## ■ POWER SEAT

### General

**Driver Seat**

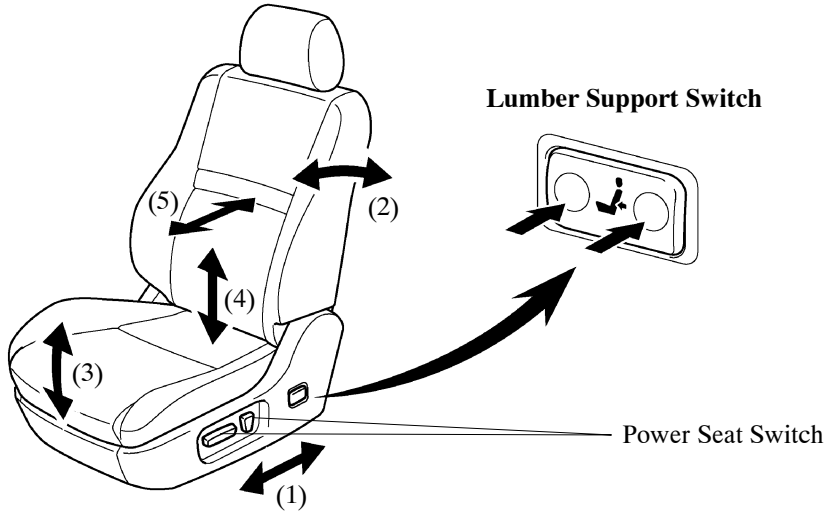
- The lumber support in the driver seat has been changed from the manual type on previous Camry to the power type on new Camry.
- The following features are all for power functions.

▭: New

| | Power Adjustment Function | | Stroke | Application |
|---|---|---|---|---|
| (5) | Power Lumbar Support | mm (in.) | 34 (1.34) | Standard |
